# UNITED STATES PATENT AND TRADEMARK OFFICE

APPLICATION NO.	FILING DATE	FIRST NAMED INVENTOR	ATTORNEY DOCKET NO.	CONFIRMATION NO.
10/603,126	06/23/2003	Scott Seamans	40130-050100	9833

**Office Action Summary**

## **DETAILED ACTION**

Fig. 1

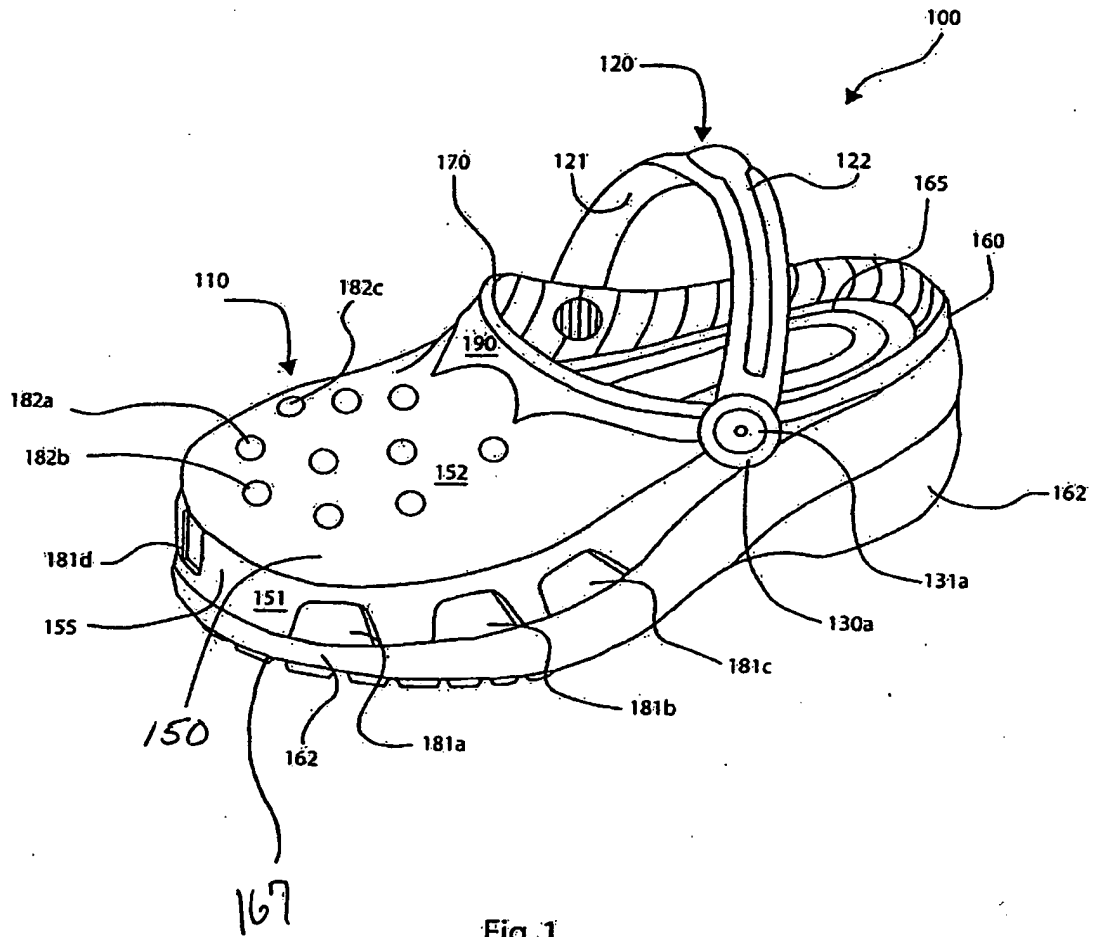
The attached replacement sheets include changes made in Figs. 1, 3 and 5 and replace the original sheets containing those drawings. In Fig. 1, element 156 has been changed to 150 and previously omitted element 167 has been added. In Fig. 3, previously omitted element 166 has been added. In Fig. 5, previously omitted element 168 has been added.

Approved for entry.  
05-12-05
